I am writing on behalf of the Center for Energy & Economic Development, Inc., (CEED) regarding the Draft Final Technical Memorandum furnished to MRPO by EC/R, "Reasonable Progress for Class I Areas in the Northern Midwest – Factor Analysis" (July 18, 2007). Please post an electronic copy of these comments on the MRPO website.

#### Summary of Comments

**Figure ES-3. Changes in annual mean PM<sub>2.5</sub> with EGU1 with IPM candidate control program.**

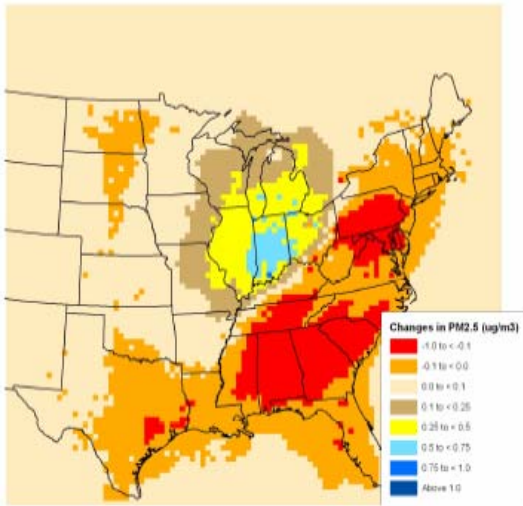
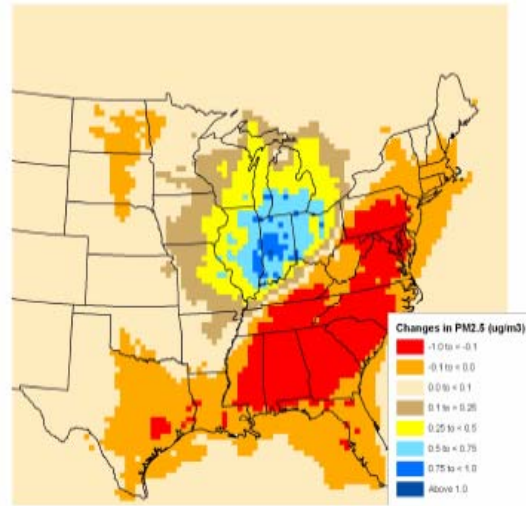
Stratus' health impact findings, summarized in the national IPM cases below, indicate that the potential downwind impacts of emissions "leakage" from the MRPO region largely or wholly offset the benefits of controls imposed within the MRPO. The net benefits of the EGU1 strategy are projected to be negative:

When unrestricted emission trading is permitted, the emission reductions resulting from EGU1 and EGU2 controls within the MRPO region generate tradable allowances that can be sold outside the region. The 2006 Stratus analysis illustrated the effects of such trading in states outside the MPRO region, based on IPM modeling of annual PM<sub>2.5</sub> concentrations:
